TENNESSEE VALLEY AUTHORITY

Enclosed is Revision 4 of TVA's response to the Auxiliary Systems Branch (ASB) fire protection review questions for the Sequoyah Nuclear Plant. This information was requested in your letter to N. B. Hughes dated September 1, 1978. The original information, Revision 1, Revision 2, and Revision 3 were submitted by my letters to you dated November 9, 1978, December 19, 1978, January 19, 1979, and March 8, 1979, respectively. This revision includes:

AUXILIARY SYSTEMS BRANCH
FIRE PROTECTION REVIEW
SEQUOYAH NUCLEAR PLANT - UNITS 1 AND 2
DOCKET NUMBERS 50-327/328

Figure 3.E.(iii)-1

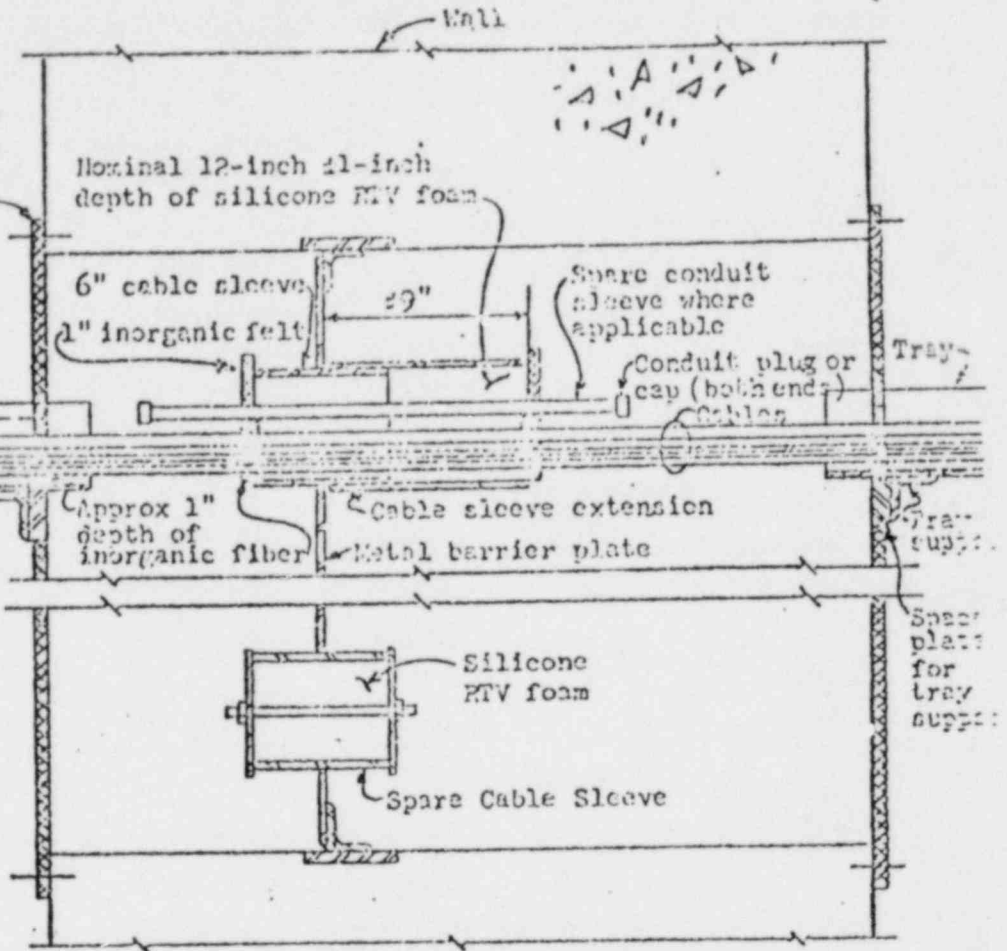
- (iii) Fire barrier penetration seals around ducts, pipes, cables, cable trays, and conduit or any other openings. Verify that the seals will meet the 3 hr. requirements for ASTM E-119. Verify that the inplant cable tray supports are similar to the ones used in the fire tests and that, in case of collapse of the trays, the resultant unsupported load and torque on the penetration seal will not affect the integrity of the seal.

The design of the inplant cable tray supports are typically shown in Figures 3.B.(iii)-1 and 3.B.(iii)-2 for wall and floor penetrations with cable trays, respectively. During the tests conducted by TVA, warpage of the cable trays and supports was observed to occur outside the cable coated area. No visual distortion of the cable trays or their supports was observed at the wall opening following the test.
